Retailer Technical Journal 14545

Water intrusion into passenger compartment S40 / V50

Date 10-7-2008

Volvo Cars of North America, LLC
Technical Support

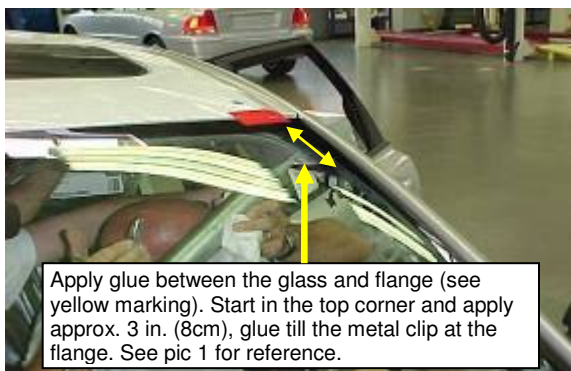
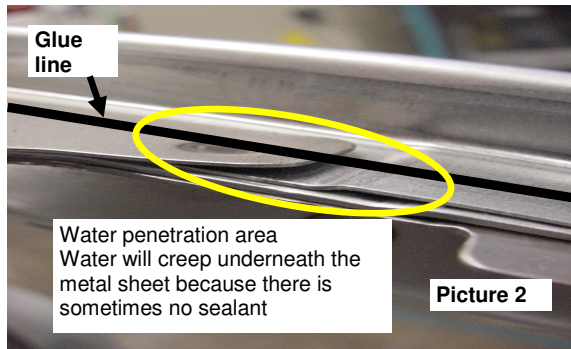
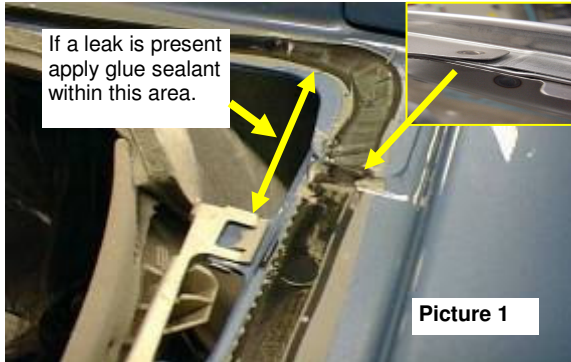
Remove the retaining clip, shown here and replace when trim the panel is reinstalled.

Note: windscreen removed in these pictures to identify concern. There is no need to remove the windscreen for this repair.

From inside the vehicle be sure no water is entering the area. If so, locate the exact spot (pictures 1 & 2 might give you a hint of a possible location)

If no leak is detected install a new retaining clip (PN 30781445) on both A pillars, install the cover panels and proceed to the next possible cause. See page 4

If a leak has been detected, do not remove the windscreen, perform the following:

- dry the area completely with compressed air
- apply sealing compound (PN 1161767) by use of a generic sealant gun. (insert a small spacer between the headliner and flange in the top corner for better access)
- ensure the application of sufficient amount of sealant, remove excess sealant with a 'wet' finger or spatula
- after the sealant has hardened (approx 6 hrs), check the water tightness of the area again.

- install a new retaining clip (PN 30673305) to both A pillars
- install both A pillar trims

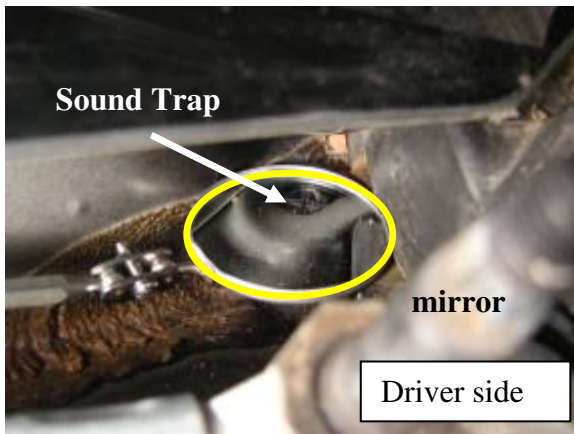
Gently pull the headliner inward and with a mirror inspect that the drain hose is connected to the sunroof tub correctly.

Inspect the installation, location and condition of the drain. It should look the same as the one shown here.

View of the sound trap exit.

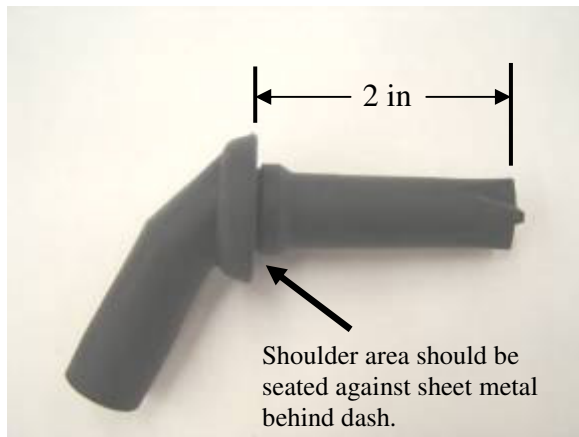
Note the shape and location of the sound trap.

You can place your finger(s) on the tip of the sound trap. It should be slightly higher then the opening in the sheet metal.

A change to the sound trap has taken place (PN 30784158) **NOTE:** There is no part number change from the original, but the new sound traps have a length of 2 inches (52 mm) from bottom to flange to exit.

If you have a clogged drain system and have confirmed it is not the sunroof assembly or the drain hose: Remove the sound trap from its installed position and ensure it is not blocked or deformed. If it is replace with a new one (PN 30784158).

When installing the sound trap: It is difficult to see the sound trap when installed, feel with your hand and be sure the trap is installed up to the shoulder area (see above), and inspect the position from the cowl area as described previously.

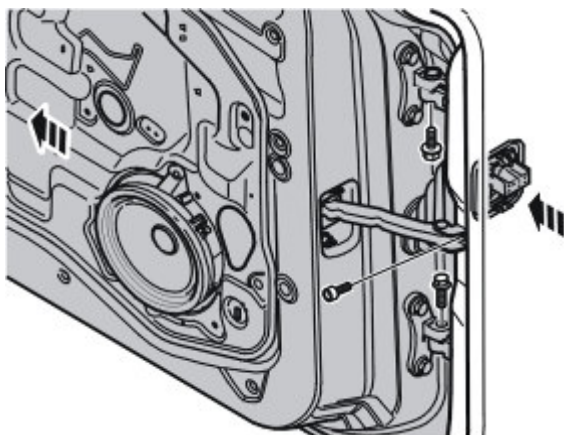
Be sure the marked area is tested thoroughly.

NOTE: Only driver side is shown. However the same issue can occur at either the driver or passenger sides.

With the water running; check if water enters either around the instrument panel mounting bolt or the area directly surrounding.

- dry the area completely with compressed air
- seal the marked are with sealing compound (PN 1161767) make sure the area is completely sealed
- after the sealant has hardened (approx 6 hrs), check the water tightness of the area again.
- if the area is now sealed touch up the area with the appropriate touch-up paint.

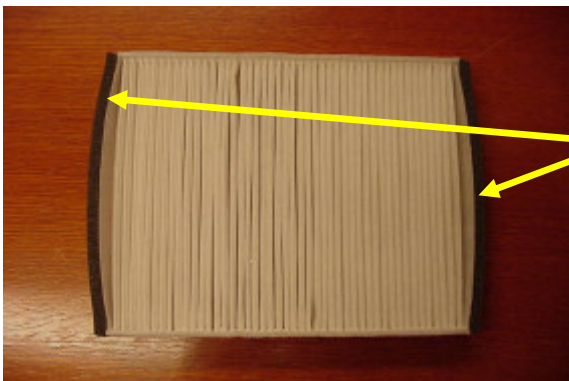
The following improvements of the cabin filter have been introduced:

- Closed cell structure foam on the sides of the filter element.
- More flexible filter core and rounded sides to follow the shape of the HVAC housing.
- Optimized dimensions of the filter element.

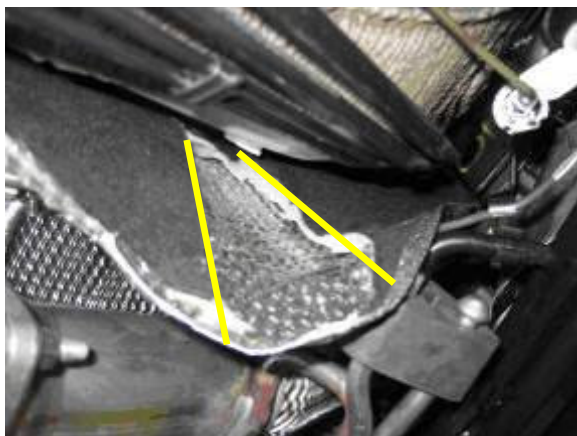
The drain for the climate unit is located in this area.

Vehicles with two wheel drive, loosen the cross member as shown here.

Vehicles with all wheel drive, loosen the cross members as shown here.

Carefully bend out the heat shield.

With a knife; slice the insulation in the area of the drain.

Once sliced; remove (scrape) the sound insulation from the area of the drain so that drainage is not restricted.
